PJM Manual M14D R71 and Voltage Support

Markets and Reliability Committee

June 24, 2026

Manual 14D: Revision 71

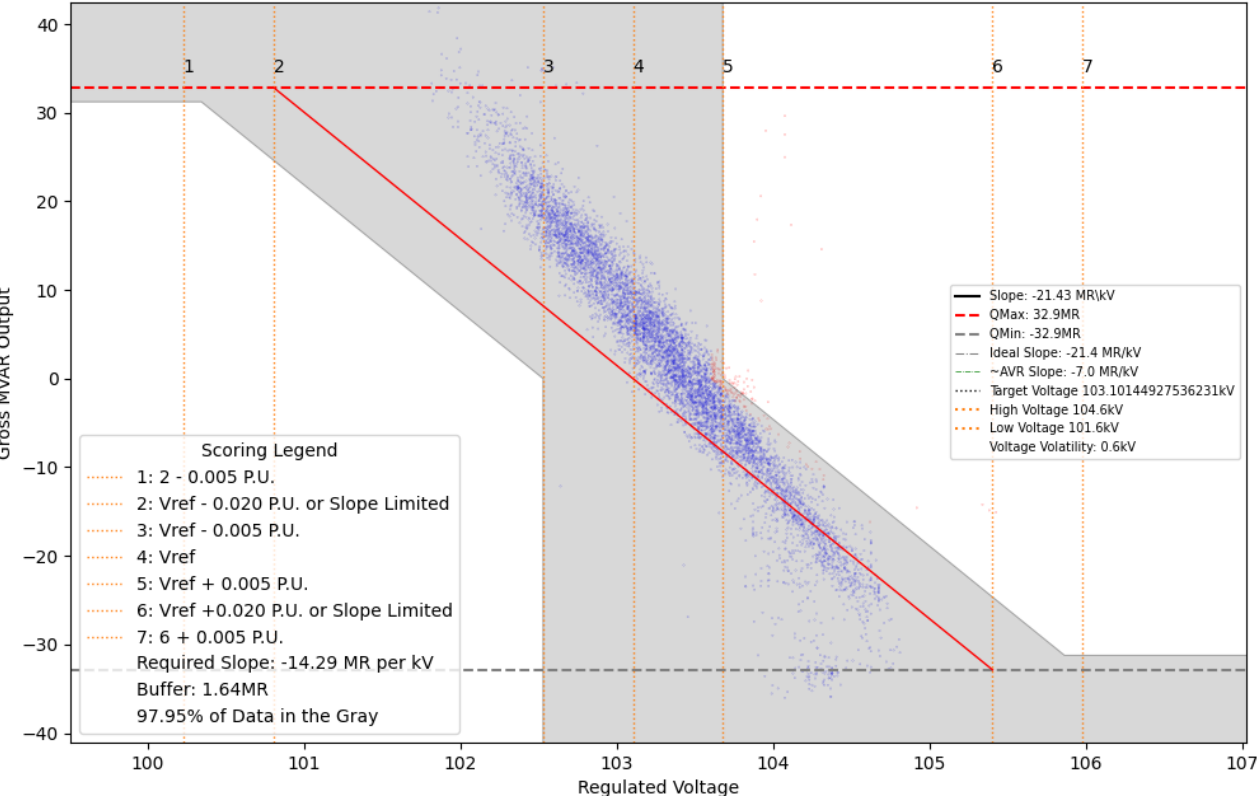
- Defines acceptable range of VAR output at any voltage.
- Gray area is acceptable.
- 32.87% relates to the standard .95 pf capability standard.

---	Max Reactive Output (Q _{max}) 32.87% of Max MW
---	Min Reactive Output (Q _{min}) -32.87% of Max MW
1	V _{ref} - 0.020 Per Unit
2	V _{ref} - 0.005 Per Unit
3	Target Voltage a.k.a Voltage Reference (V _{ref})
4	V _{ref} + 0.005 Per Unit
5	V _{ref} + 0.020 Per Unit

7.1.2 VAR Control Range Boundaries

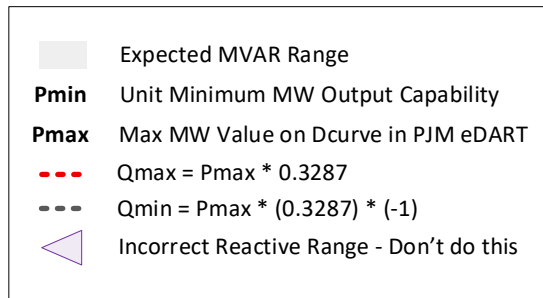
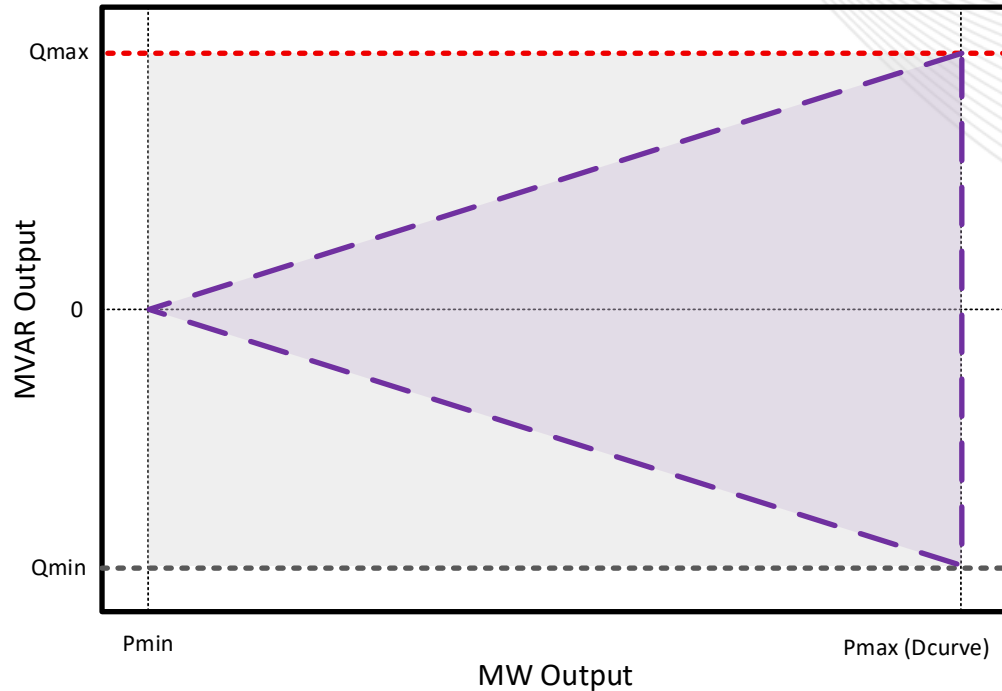
- Defines acceptable reactive control range per MW output.

Expected MVAR Range
Pmin	Unit Minimum MW Output Capability
Pmax	MFO (Max Facility Output) from Unit ISA or GIA
	$Q_{max} = P_{max} * 0.3287$
	$Q_{min} = P_{max} * (0.3287) * (-1)$

7.1.2 VAR Control Range Boundaries

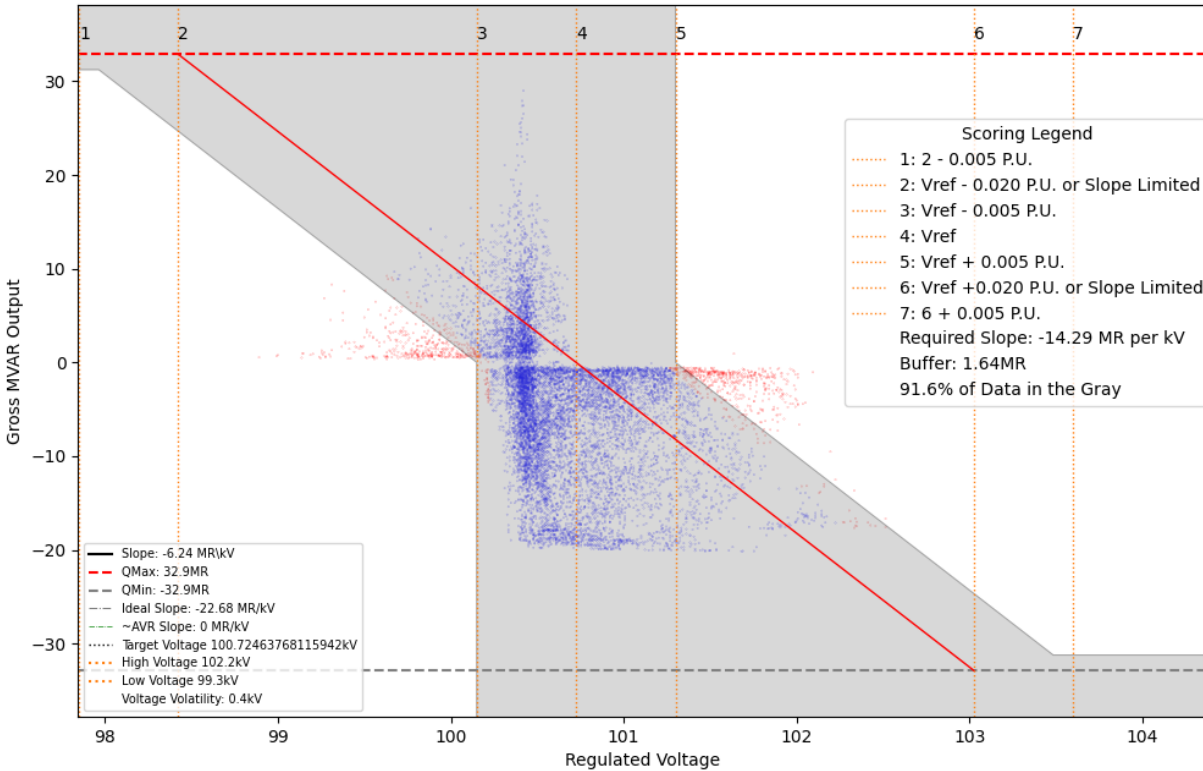
- Commonly made *incorrect* assumption or interpretation of reactive control range per MW output.
- Shown as a counter-example.
